# Access Compliance Report

Intersection ID: 10030604	Main Street: LOMA_LINDA_LN	Cross Street: N/A	Location: W
ADA ID: 07F85F73DD7C	Ramp Type: Perp	Initial Pass/Fail: Fail	Overall Compliance: No
Severity Score: 13.75			
Codes/Mitigation Info/Possible Solution		Field Measurements/Component Compliance

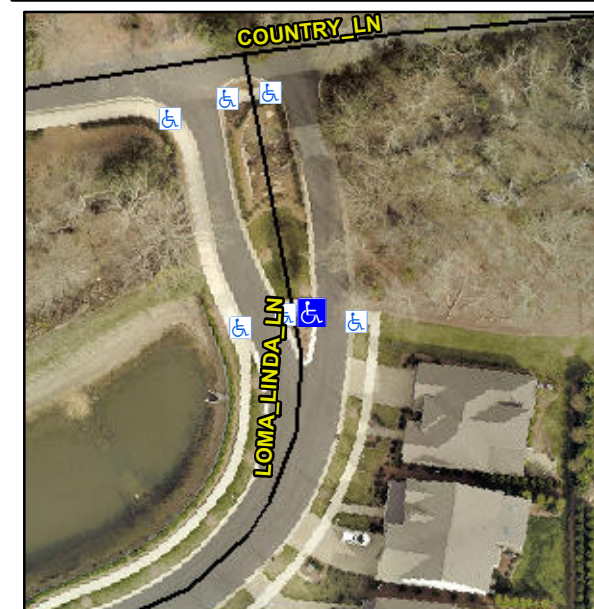
**Not Found, R304.2.2**

Compliance	Description	Data	Compliance	Description	Data
N/A	Ramp Length (in)	70.0	No	Ramp Slope (%)	11.6
Yes	Ramp Width (in)	68.0	Yes	Ramp XSlope (%)	3.0
N/A	Flare Type LT	N/A	N/A	Flare Type RT	N/A
N/A	Flare Slope LT (%)	N/A	N/A	Flare Slope RT (%)	N/A
N/A	Flare Traversable LT?	N/A	N/A	Flare Traversable RT?	N/A
N/A	Landing Length (in)	N/A	N/A	DWS Provided?	N/A
N/A	Landing Width (in)	N/A	N/A	DWS Contrast?	N/A
N/A	Landing Slope (%)	N/A	N/A	DWS Length (in)	N/A
N/A	Landing X Slope (%)	N/A	N/A	DWS Full Width?	N/A
N/A	Landing Curb? (Y/N)	N/A	N/A	DWS Offset (in)	N/A
N/A	Shared Landing?	N/A			
N/A	Gutter Ponding?	N/A	N/A	Gutter Slope (%)	N/A
N/A	Gutter Lip Ht (in)	N/A	N/A	Gutter X Slope (%)	N/A
N/A	Painted X Walk1?	No	N/A	Painted X Walk2?	N/A
	X Walk 1 Direction	To E		X Walk 2 Direction	N/A
N/A	X Walk 1 Width (in)	N/A	N/A	X Walk 2 Width (in)	N/A
	X Walk 1 Slope (%)	0.9		X Walk 2 Slope (%)	N/A
	X Walk 1 X Slope (%)	5.4		X Walk 2 X Slope (%)	N/A

**Remove & Replace Entire Ramp.**
